AMENDMENT OF SOLICITATION/MODIFICATION OF CONTRACT				1. CONTRACT ID CODE		PAGE OF PAGES		
2. AMENDMENT/MODIFICATION NO.			3. EFFECTIVE DATE		4. REQUISITION/PURCHASE REQ. NO.		5. PROJECT NO. (If applicable)

4. Delete Sheets G-001, P-104, M-101, M-504, M-602, MI105, and MI108 and replace with the attached Sheets G-001, P-104, M-101, M-504, M-602, MI105, and MI108.

REPAIR BEQ HP510

PROJECT NO.: 18-0042

MI108

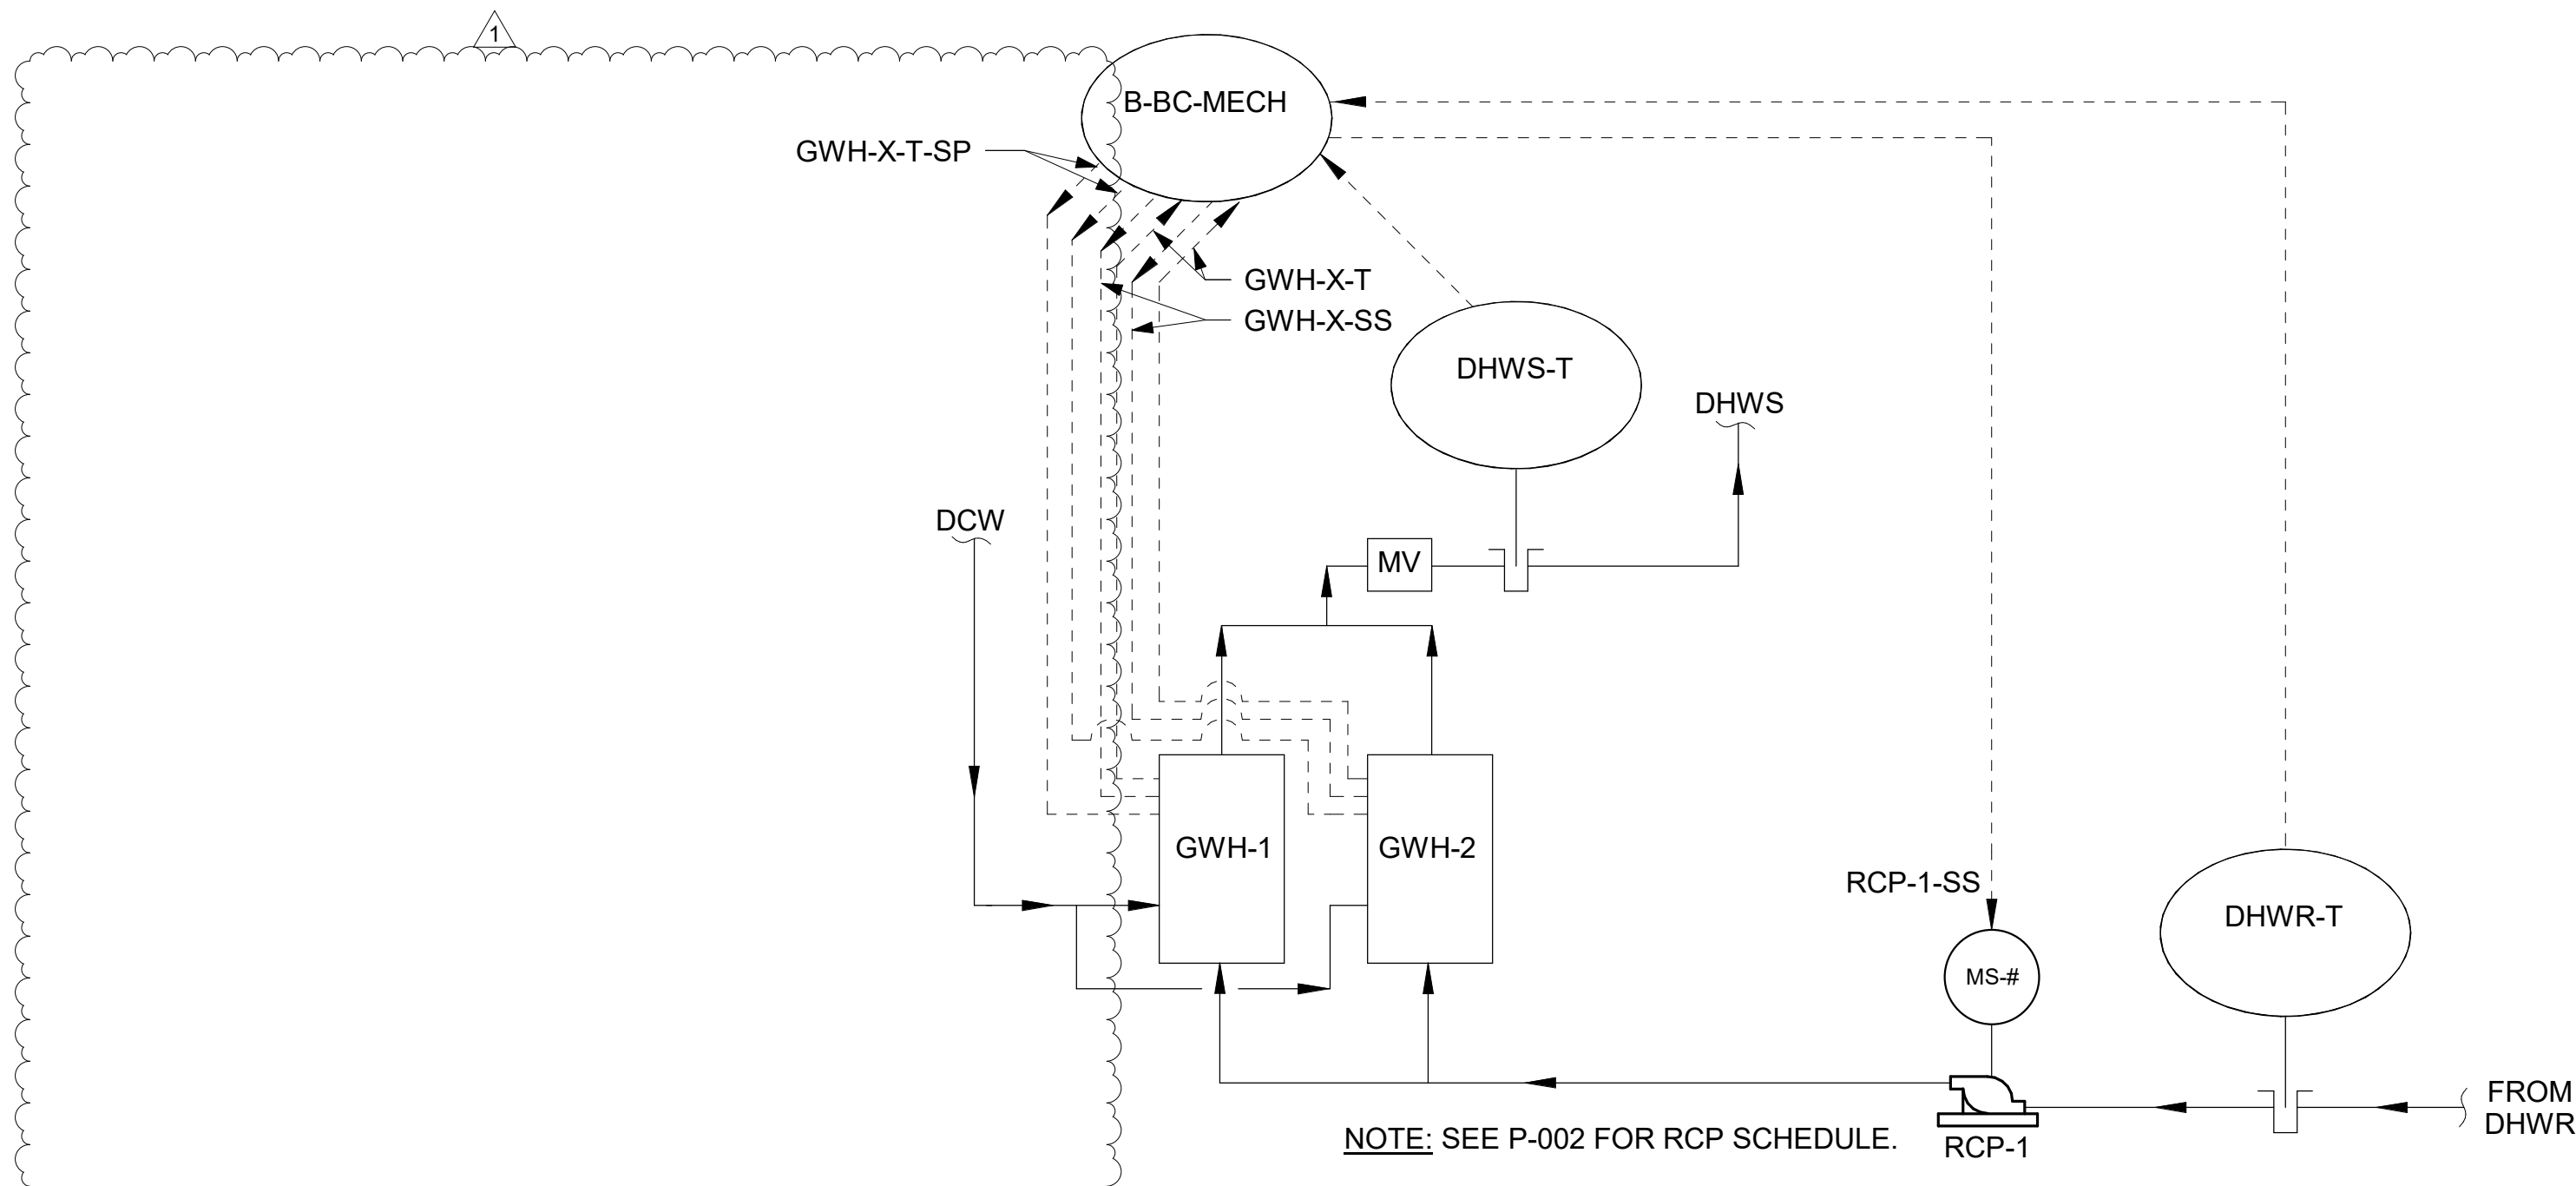
REVISIONS			
SYM.	DESCRIPTION	DATE	APPROVED
1	REMOVE ALL HEAT RECOVERY SYSTEMS	08/10/20	PCM
